# Austin Transportation Department

May 25, 2021

RE: I-35 Capital Express South Project  
Comments for Public Hearing

# Bicycle and Pedestrian Crossings

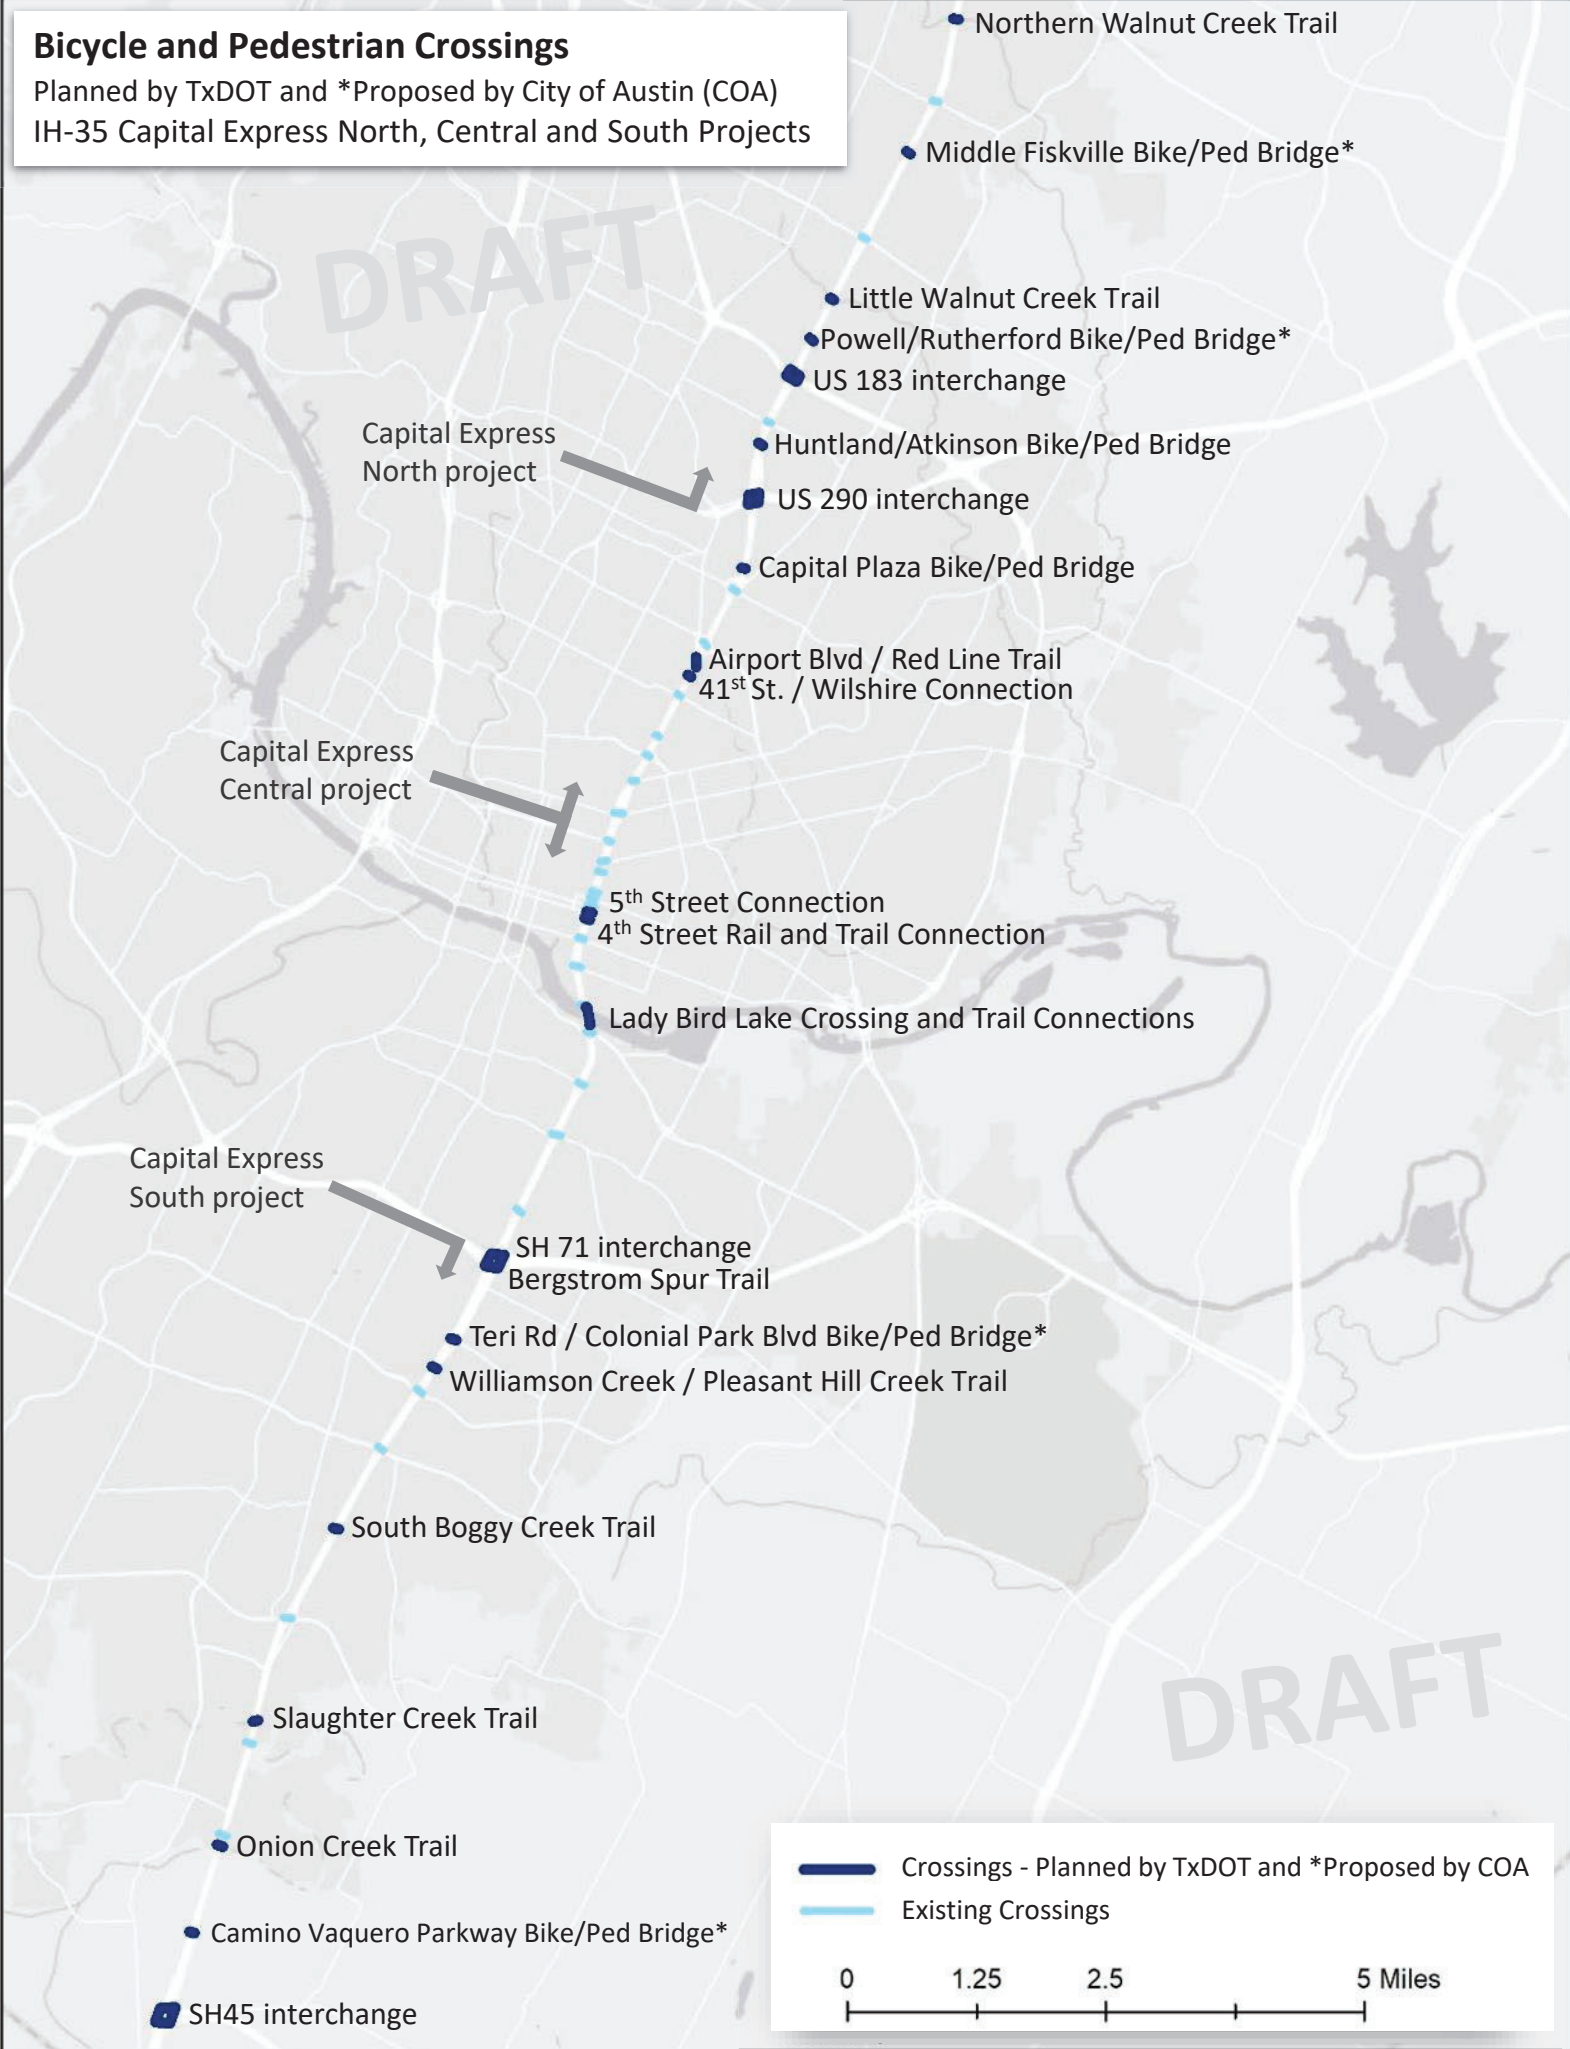
**Multimodal Crossings:** Plans for the South segment currently propose no new east-west crossings. The City has transmitted requests to TxDOT for additional pedestrian and bicycle crossings in letters dated January 4 and January 19, 2021. Many crossings are included in the City's adopted Urban Trails and Park master plans. These crossings would reduce connectivity gaps, remove mobility barriers for lower income populations, and mitigate hot spots for pedestrian-involved crashes. The City requests continued coordination with TxDOT to assure the design of the Capital Express South project does not preclude or complicate these proposed future crossings. A map of these proposed crossings for the Capital Express South project is attached. The Austin Transportation Department is interested in partnering with TxDOT to bring these proposed crossings to fruition.
